Well Name: KITE FEDERAL	Well Location: T23N / R7W / SEC 20 / SWSW / 36.207853 / -107.603974	County or Parish/State: SANDOVAL / NM
Well Number: 1	Type of Well: OIL WELL	Allottee or Tribe Name:
Lease Number: NMNM81638	Unit or CA Name:	Unit or CA Number:
US Well Number: 300432083300S1	Well Status: Producing Oil Well	Operator: DUGAN PRODUCTION CORPORATION

Type of Action: Plug and Abandonment

Attachment to notice of Intention to Abandon

BLM - FFO - Geologic Report

Planned P & A Procedure

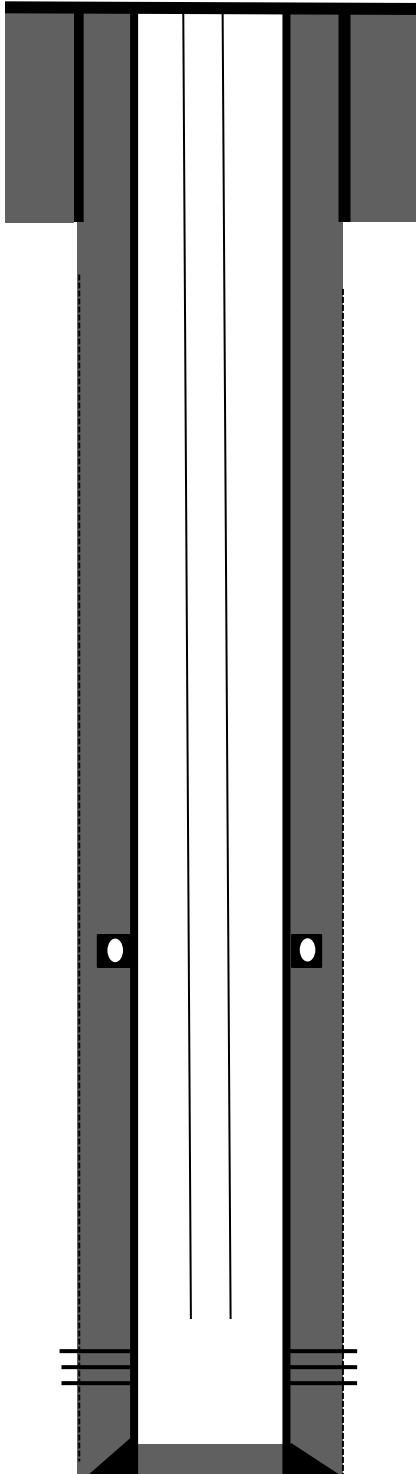
1. Plugging operations authorized are subject to the attached "General Requirements for Permanent Abandonment of Wells on Federal and Indian Lease."
2. Farmington Office is to be notified at least 24 hours before the plugging operations commence at (505) 564-7750.
3. The following modifications to your plugging program are to be made:
 - a) Plug 2: Must be moved to 4230 feet to 4080 feet to cover the BLM pick for the Manco Shale top with 50 feet excess.
 - b) Plug 3: Significant differences between the Operator's and the BLM Geologist's picks for the Lewis Shale/ Mesa Verde Group tops. Because of this adjust Plug 3 to cover the interval from 3170 feet to 2503 feet.
 - c) Plug 4: Include 50 feet more of cement. Top of cement should be 937 feet.

-Plug 2 must be moved to cover 4230' - 4080' because of the BLM top and 50' required excess.

-There is a significant difference between the Operator's and the BLM Geologist's picks for the Lewis Shale/Mesa Verde Group tops. This results in a longer Plug 3: 2503' - 3170'.

- The description for Plug 4 leaves out the 50' required excess cement.
